**Town of Kittery  
 Planning Board Meeting  
 September 8, 2022**

**28 Wyman Avenue —Sketch Plan Review, Cluster Residential Development**

Action: Accept or deny plan as complete; continue application to a subsequent meeting: Pursuant to Title 30-A M.R.S.A. §4401-4408 *Municipal Subdivision Law* and §16.8.10.H, *Cluster Residential Development* of the Town of Kittery Land Use and Development Code, owner Lusitano, LLC requests approval for a cluster residential development proposing three (3) single-family residences as a condominium on real property with an address of 28 Wyman Avenue (Tax Map 16, Lot 148) located in the Residential-Urban (R-U) Zone.

SHEET NUMBER:  
**C - 2**

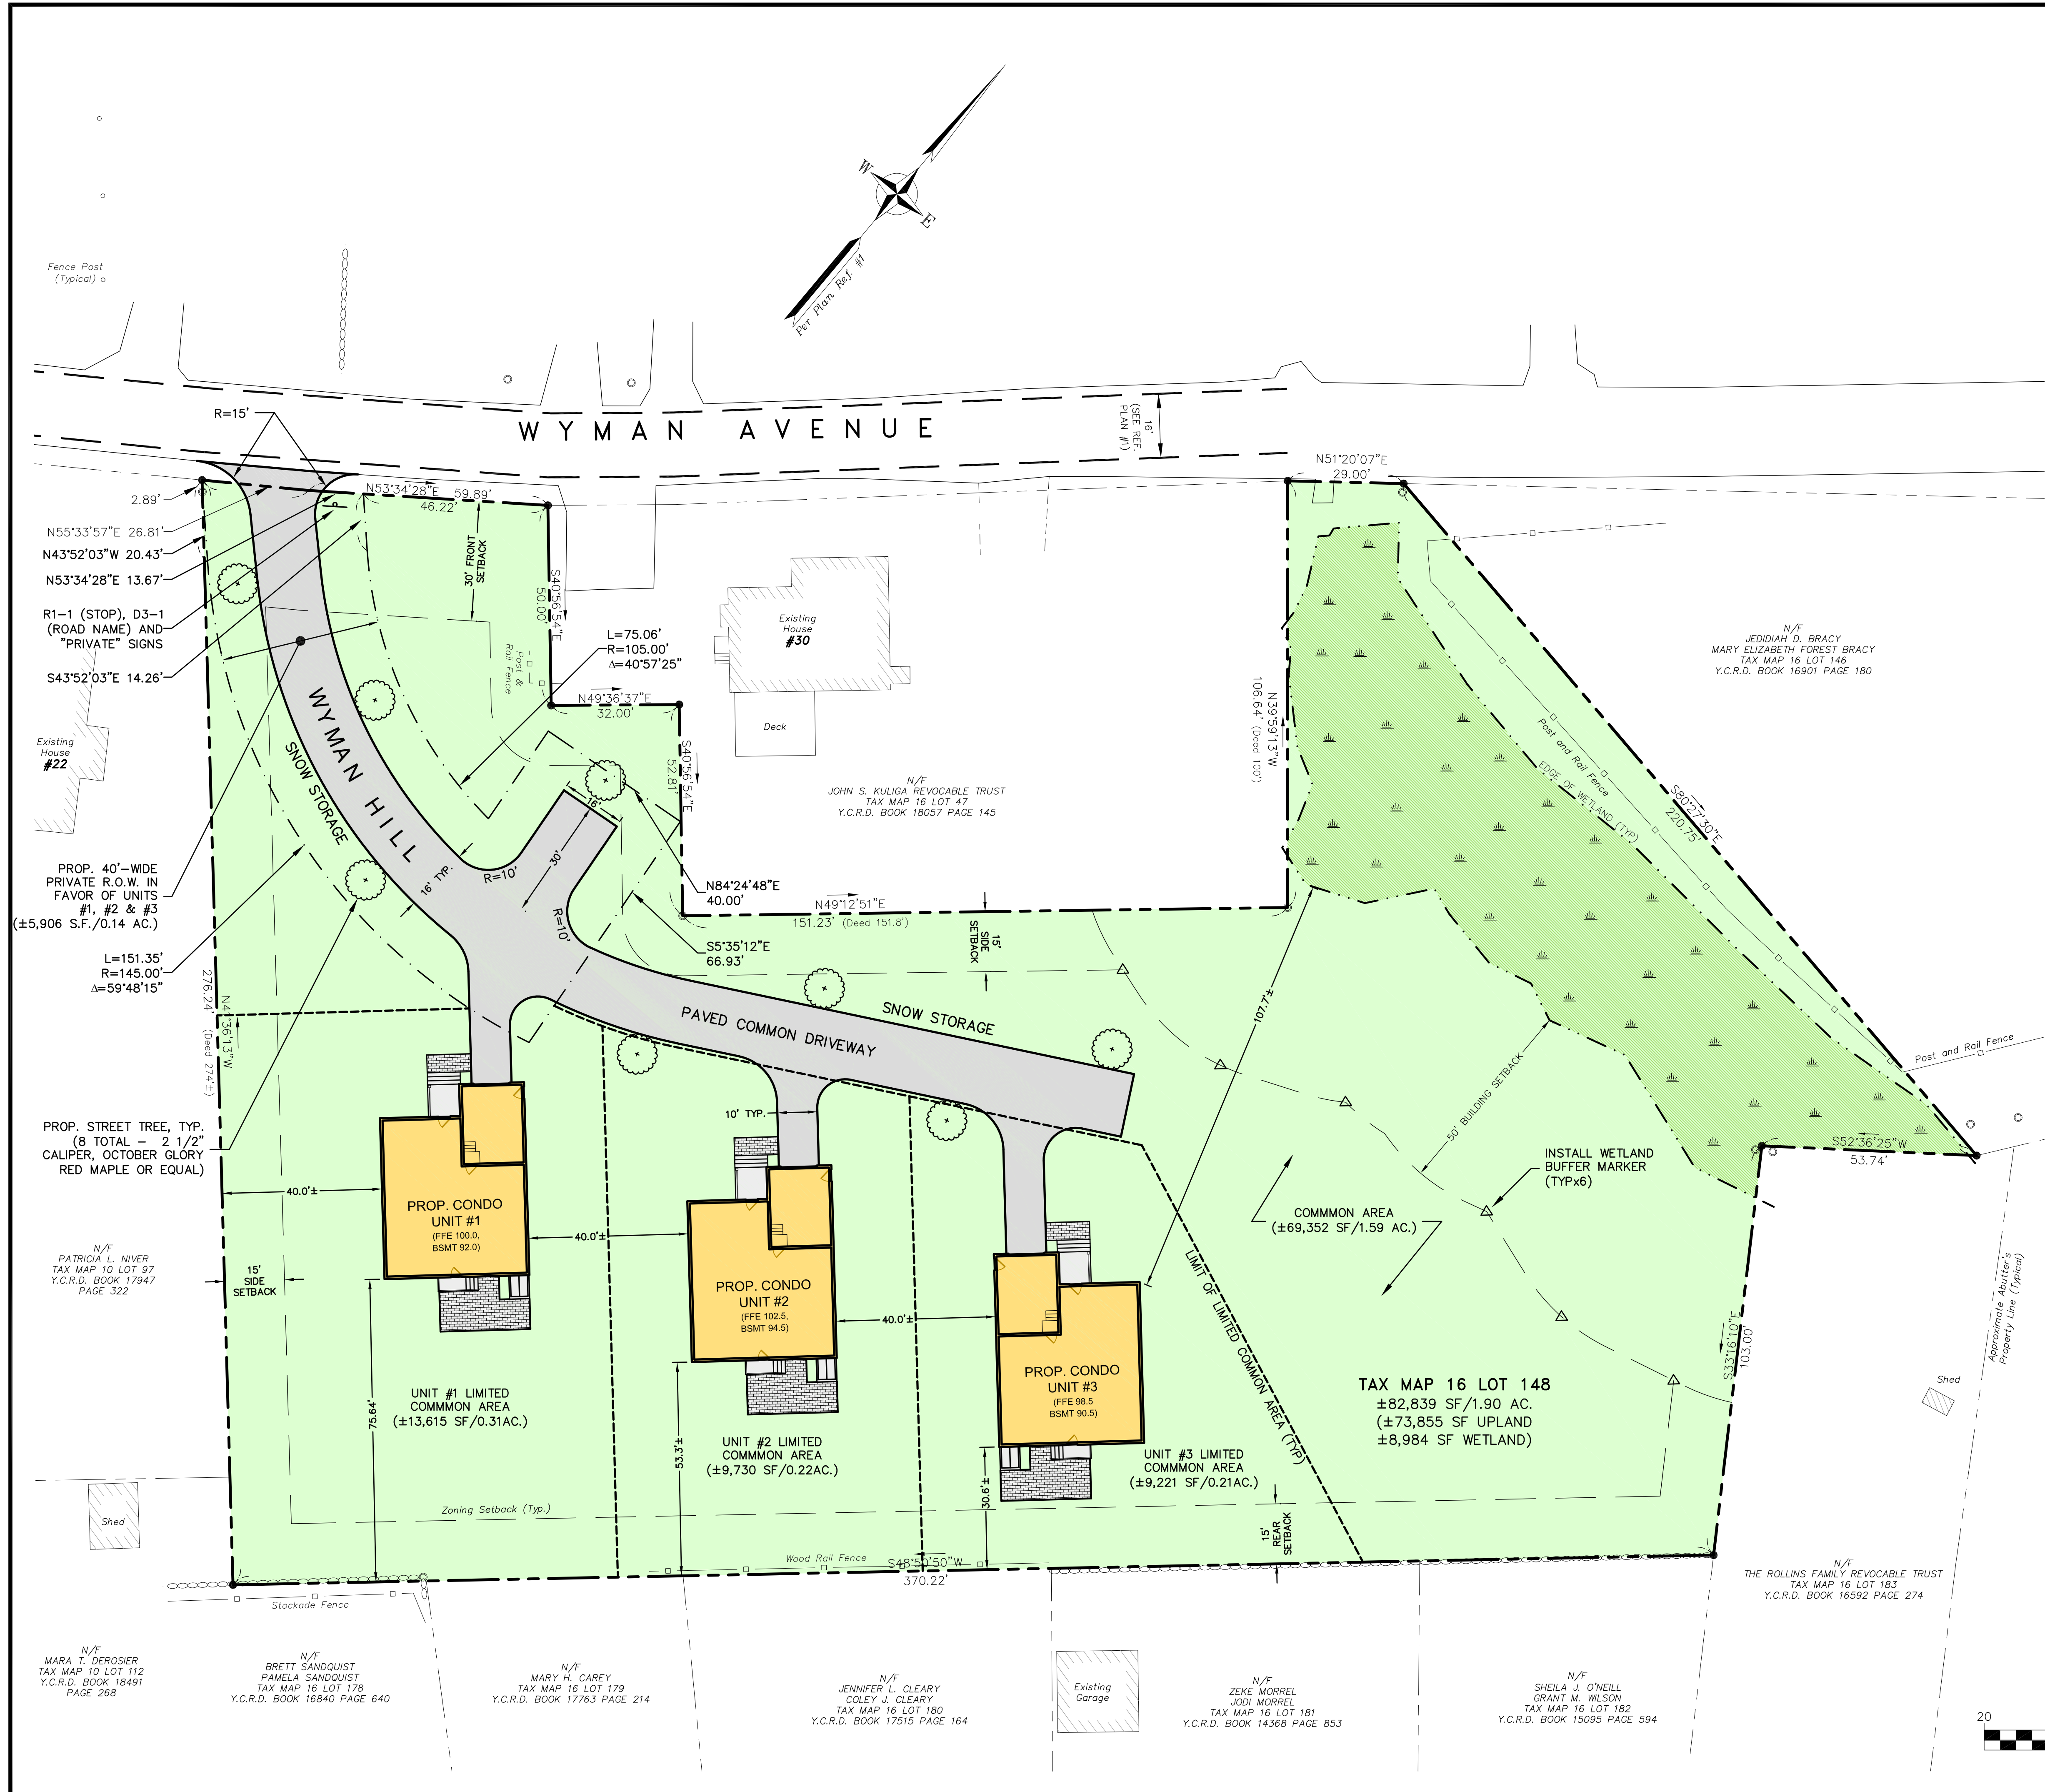
52 **Update:** The plan highlights a "Common Area" green space on sheet C-2 with the addition of where the  
53 50-foot wetland buffer markers will be installed. The common area will serve the three residences of the  
54 condominium development.  
55

84 [1] *Dimensional modifications/standards, land area identified as net residential acreage, net residential*  
85 *density* – located in plan notes and on the plans (C-2) as applicable, see additional information under  
86 *Development Standards.*

117 **Update:** June 9<sup>th</sup>'s plan did not include a turnaround that didn't require travel on private driveways. During  
118 the Technical Review Committee review, the Fire Chief required that a hammerhead turnaround be located  
119 on the private road. This plan shows the turnaround located across from Unit 1. The turnaround is noted to  
120 be 30 feet long. The Fire Chief will be asked to weigh in again on this plan.

129 Per §16.8.10.H.(6).(e), a cluster residential development must provide open space. The requirement is that  
130 50% of the lot must remain undeveloped (which usually includes all the wetlands, water bodies etc.) with  
131 30% of that comprised of upland. **Update:** Open space calculations are shown in C-2's plan note #7. While  
132 the calculations shown appear to be accurate, the note states that there is .98 acres of open space provided  
133 but below that it shows .94 acres as Common Open Space but nothing for either of the remaining two  
134 categories of open space. Where is the remaining .4 acres located?

139  
140 Recommendation: Staff recommends that the open space calculations clarify where all .98 acres of open  
141 space are and represent them suitably in the plan notes and on the plans.

SHEET NUMBER:  
**C - 4**

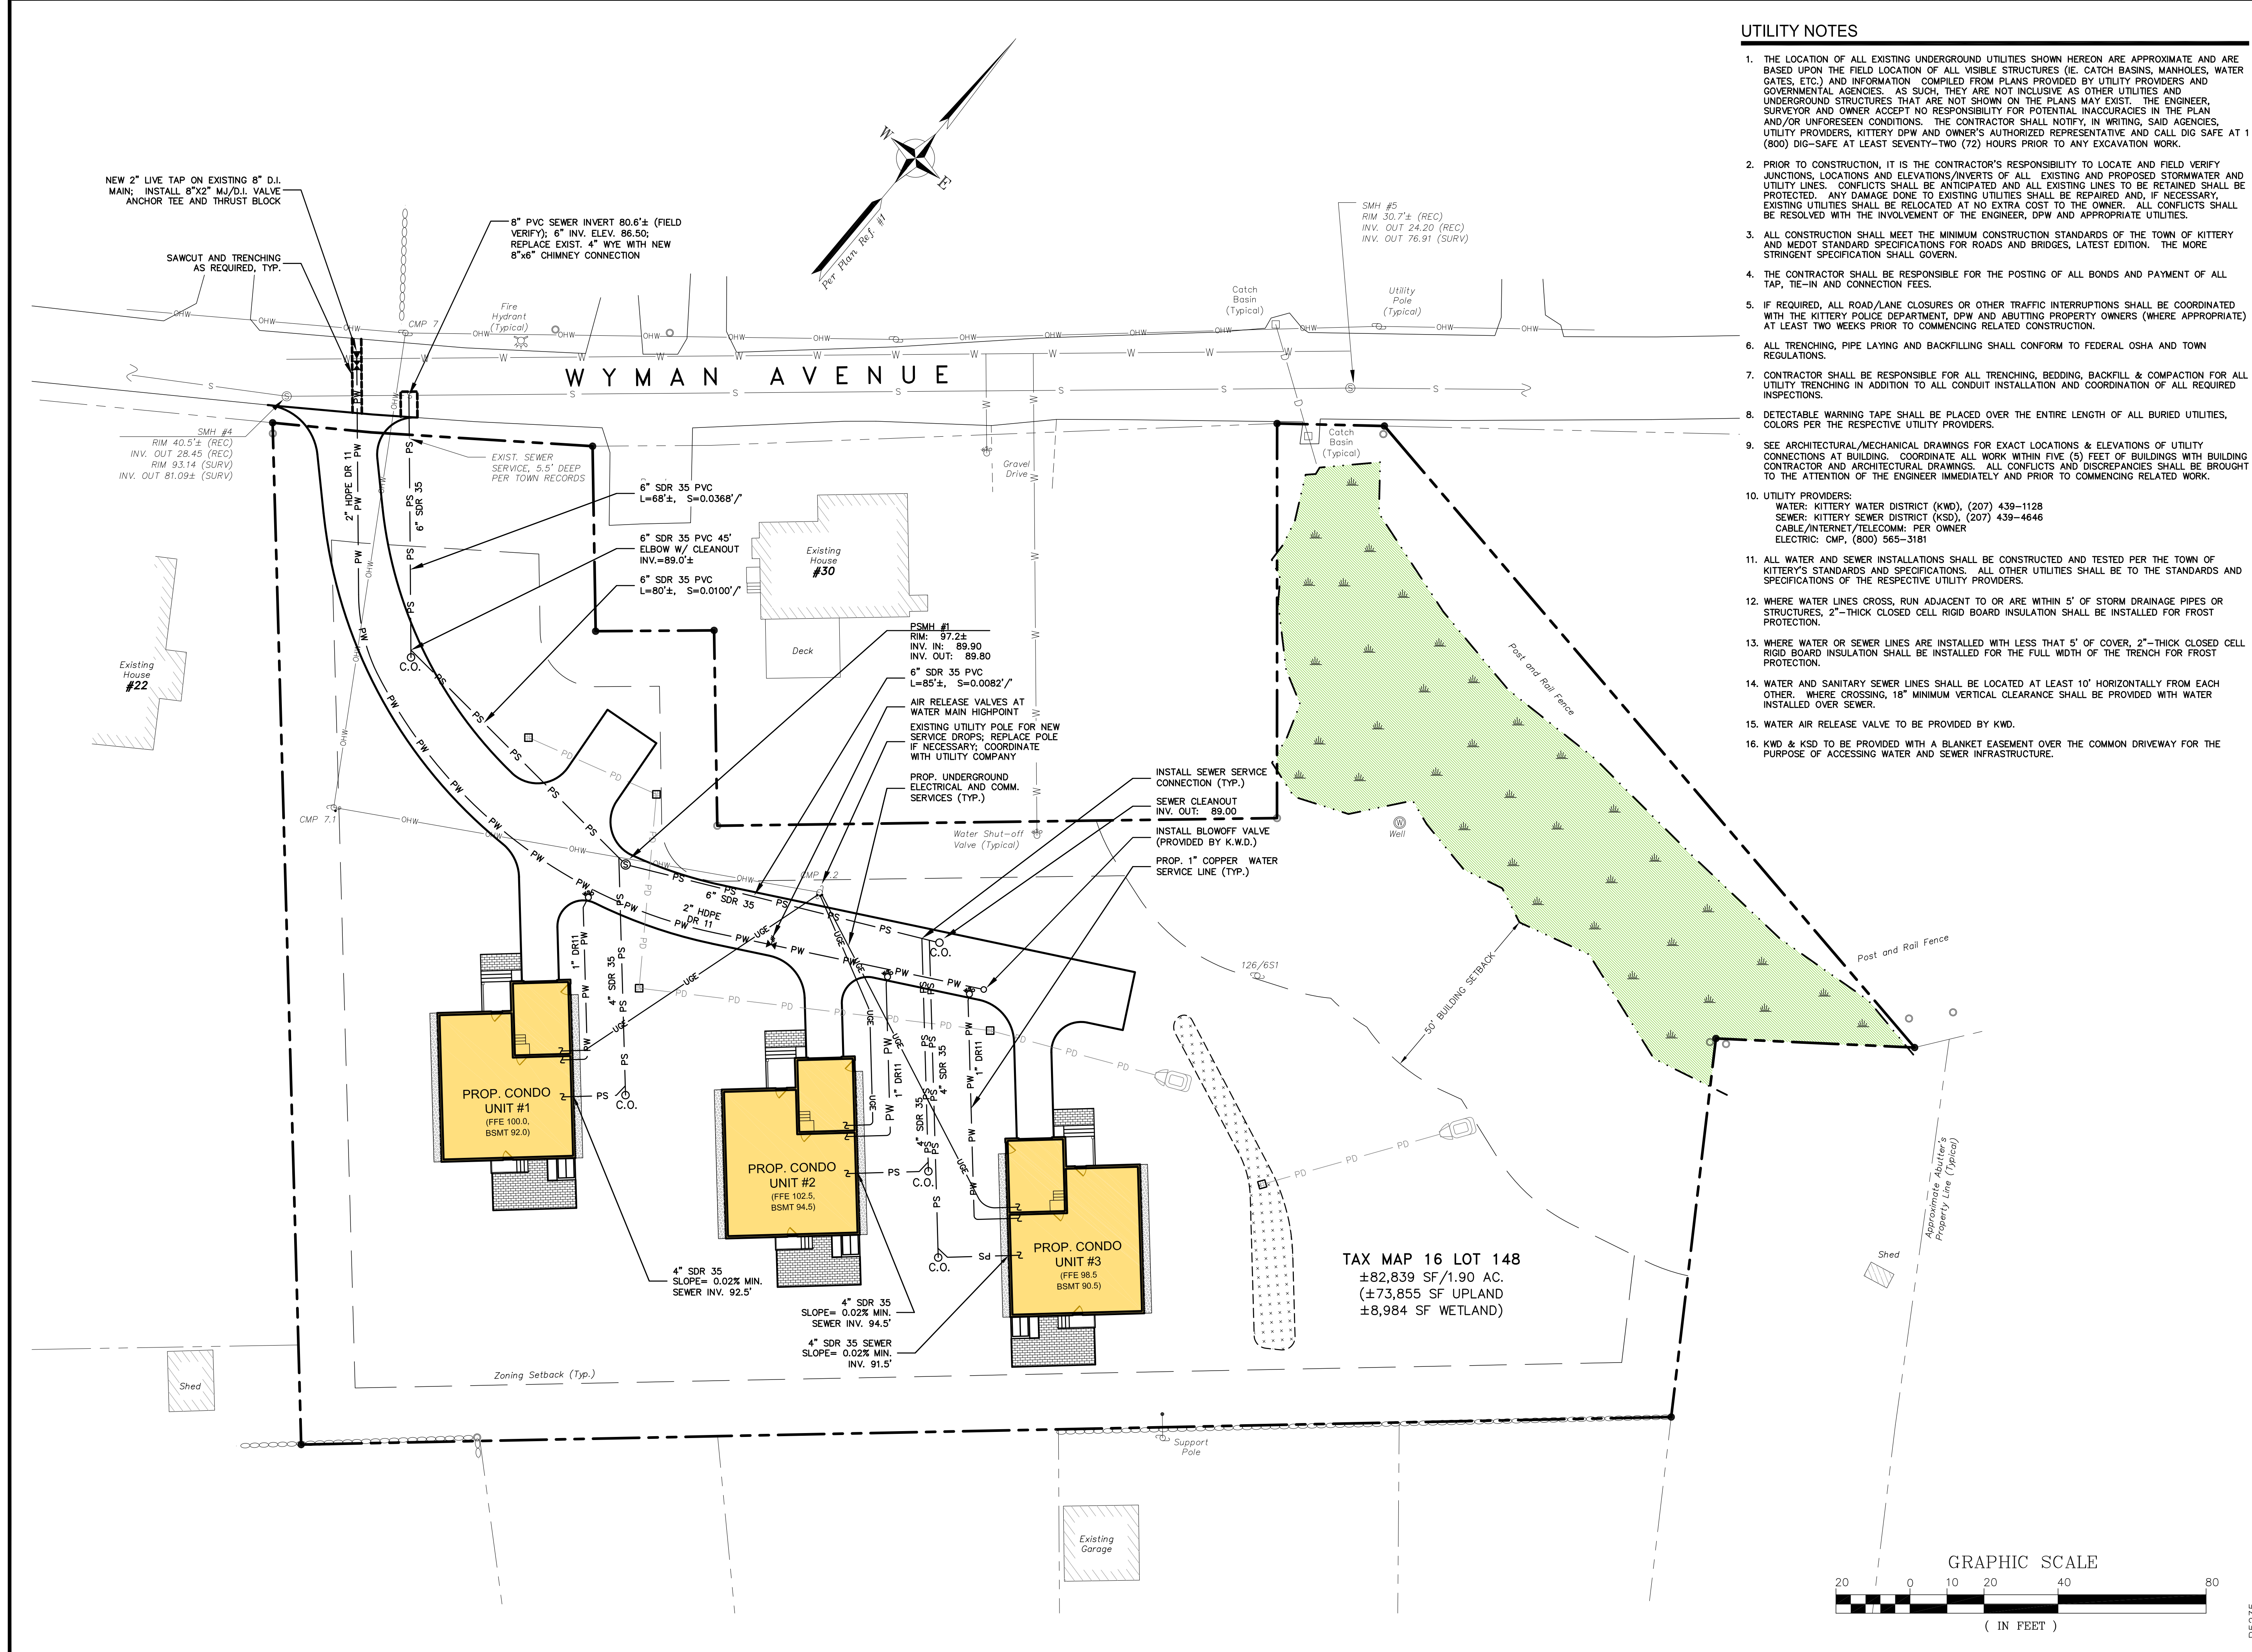
57 The site plan (sheet C-4) shows the plan for utility services. The plan shows using an existing sewer  
58 connection, as well as using an existing water connection. Existing overhead electrical lines will terminate  
59 at a new pole where underground electrical service will extend to each condo unit. A stormwater  
60 management plan has been supplied with drop inlets connected to an outfall at the eastern edge of the  
61 property. This outfall appears to be located in an area labeled "Common Area" on other plan sheets.  
62
